REMARKS

This is intended as a full and complete response to the Office Action dated April 26, 2004, having a shortened statutory period for response set to expire on July 26, 2004. Please reconsider the claims pending in the application for reasons discussed below.

FIG. 3

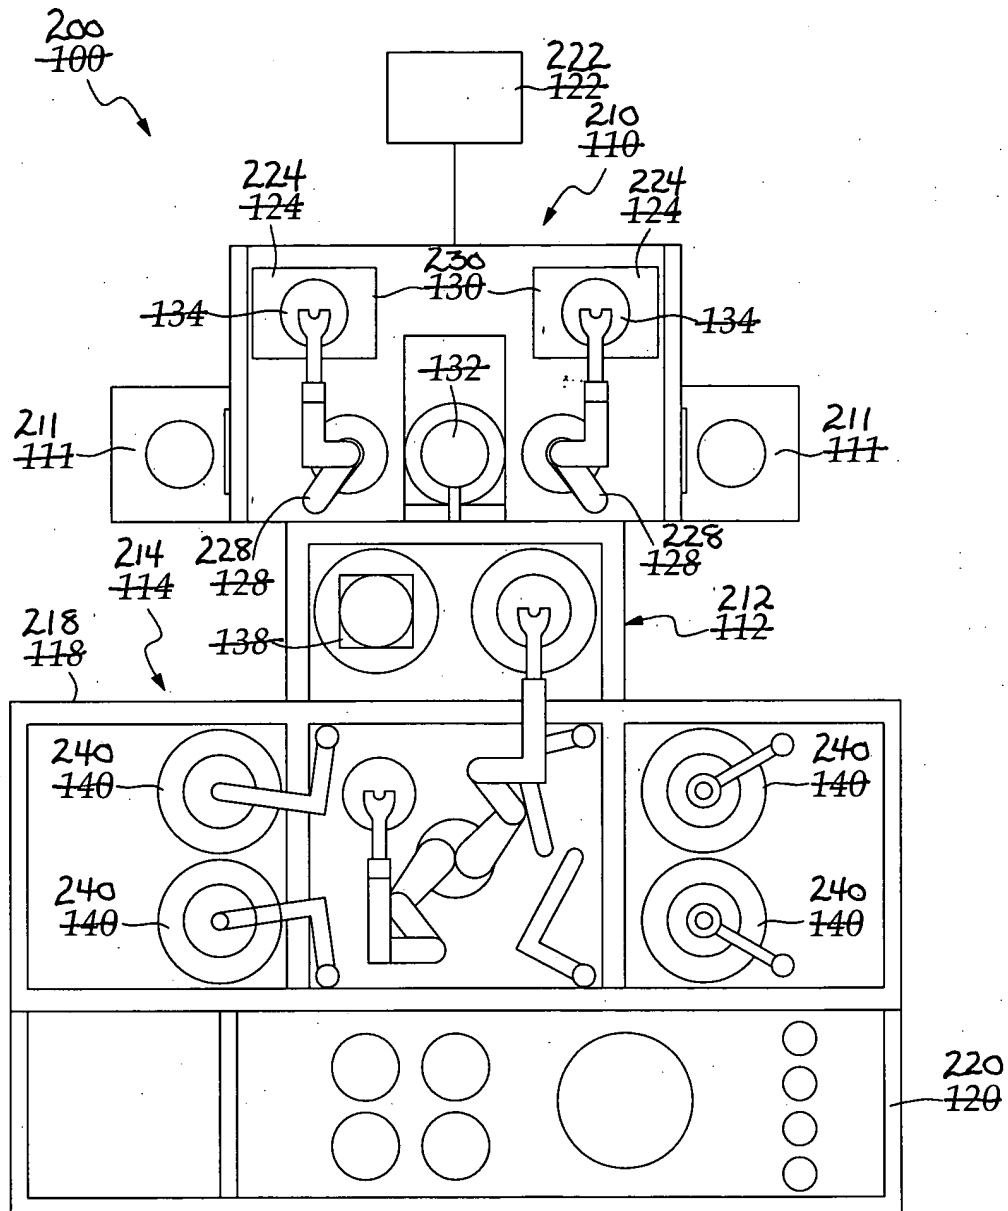
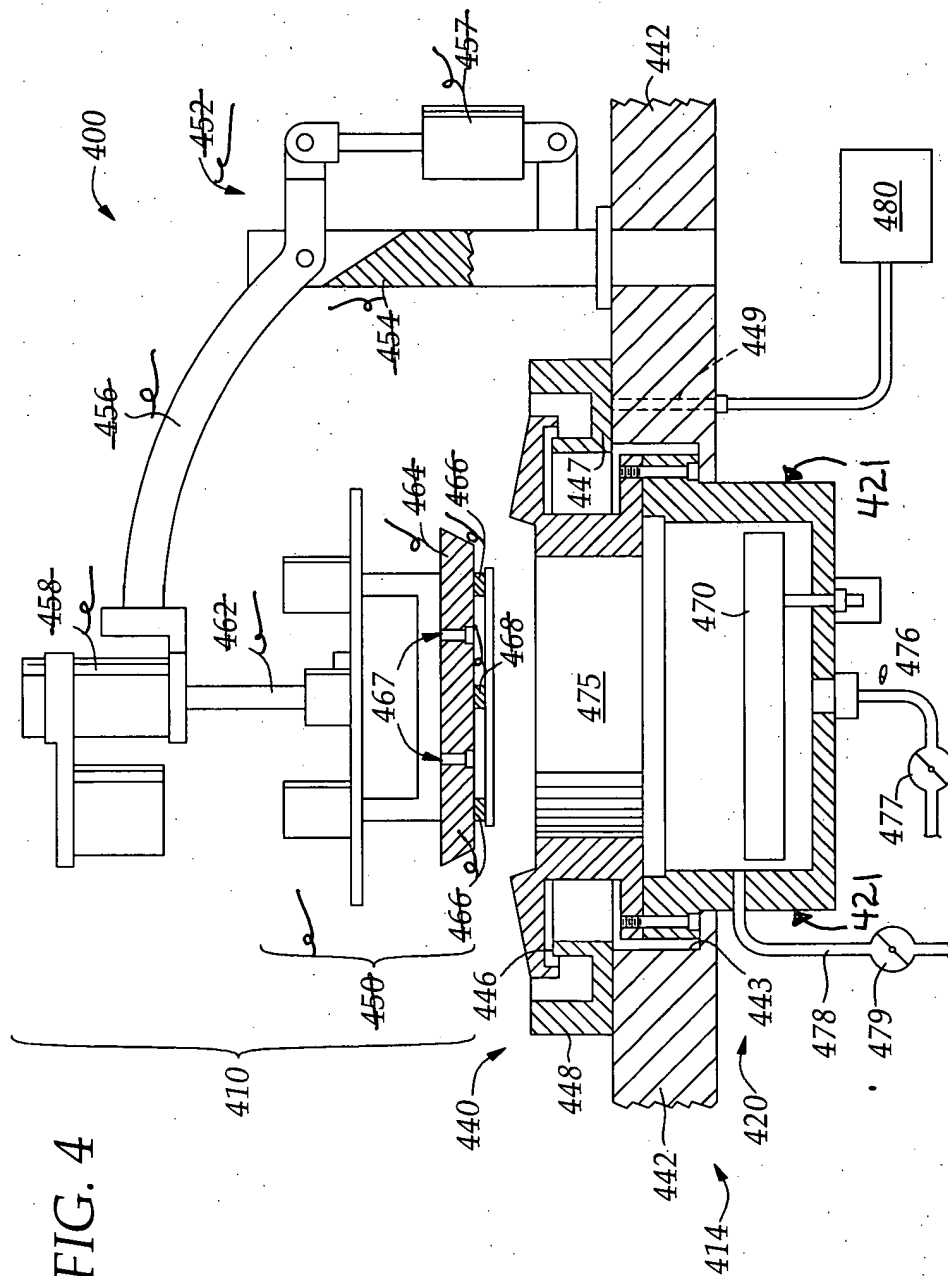
Additionally, amendments to Figure 3, and further amendments to Figures 2, 5, and 6 have been made to more clearly depict the figures as described in the specification. In Figure 3, reference numbers 100, 110, 111, 112, 114, 118, 120, 122, 124, 128, 130, and 140 have been amended to 200, 210, 211, 212, 214, 218, 220, 222, 224, 228, 230, and 240, respectively. In addition, reference numbers 132, 134, and 138 have been deleted. In Figure 2, an arrow pointing to element 211 has been added. In Figure 5, an erroneous designation of element 505 has been deleted. In Figure 6, the reference number for previously ambiguously labeled element 508 has been relocated to more clearly point out that element.

3. The reference numerals presented in Figure 3 were not defined in the specification, and the relationship between the information in Figure 3 and the information in Figure 2 was not clear. The reference numbers in Figure 3 have been amended to be consistent with Figure 2 and the text references in the specification as amended. Figure 3 as presently presented complementarily depicts the apparatus shown in Figure 2, as is described in the specification.

FIG. 5

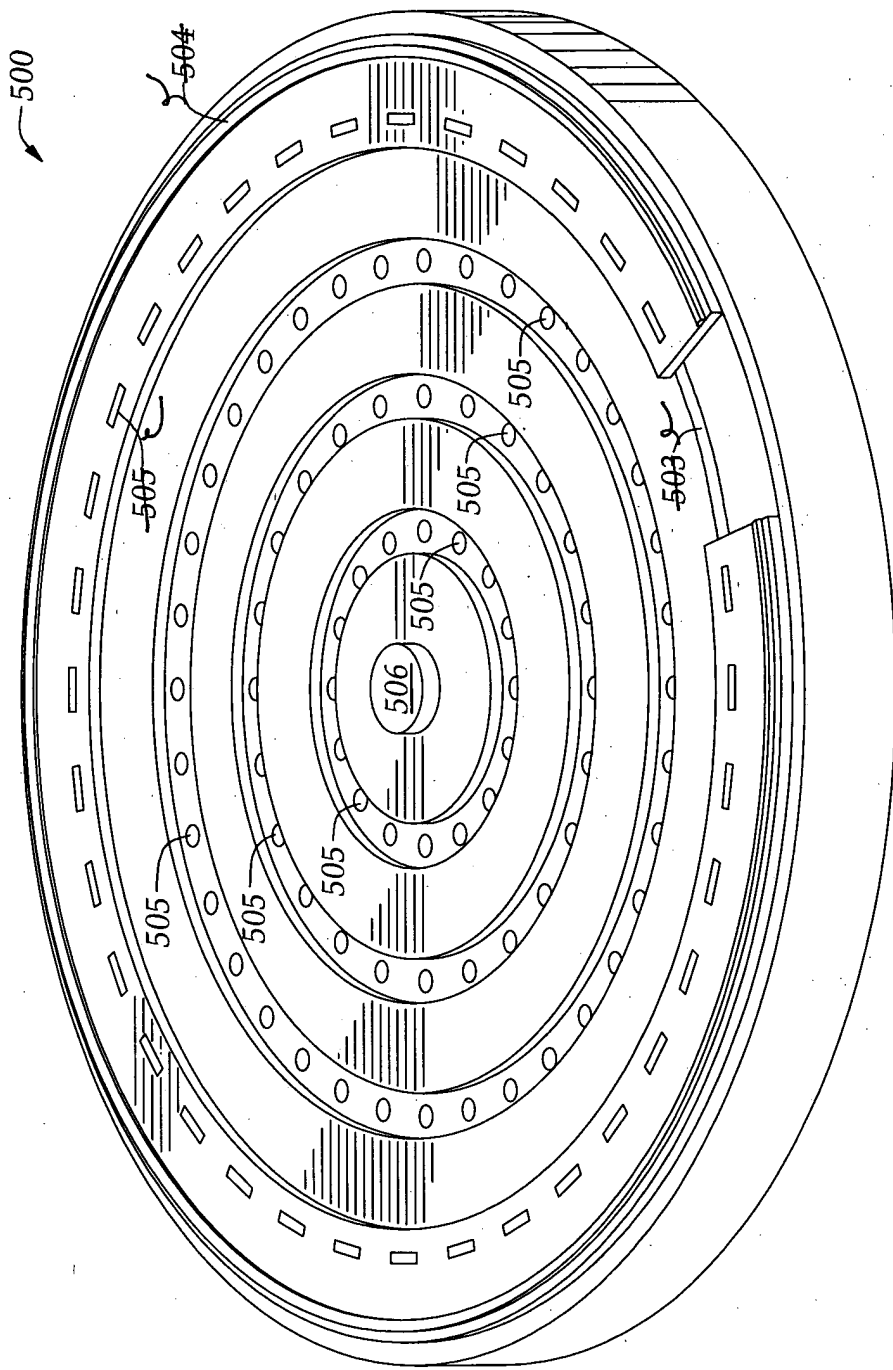
The drawings were objected to as failing to comply with 37 C.F.R. § 1.84(p)(5) because they do not include reference sign(s) mentioned in the description and/or include reference sign(s) not mentioned in the description. Figures 2, 4, 5, and 6 have been amended as required by the Examiner. In Figure 2, previously omitted reference numbers for elements 218 and 224 have been added, and the reference to mainframe transfer station 216 has been deleted from the specification. In Figure 4, previously omitted reference number 421 has been added. In Figure 6, omitted reference numbers for elements 510 and 511 have been added. Also in Figure 4, extraneous reference numbers 450, 452, 454, 456, 457, 458, 462, 464, 466, 467, and 468 have been deleted. Also in Figure 5, extraneous reference numbers for elements 503 and 504 have been deleted. Also in Figure 6, extraneous reference numbers 502, 503, 504, and 509 have been deleted.
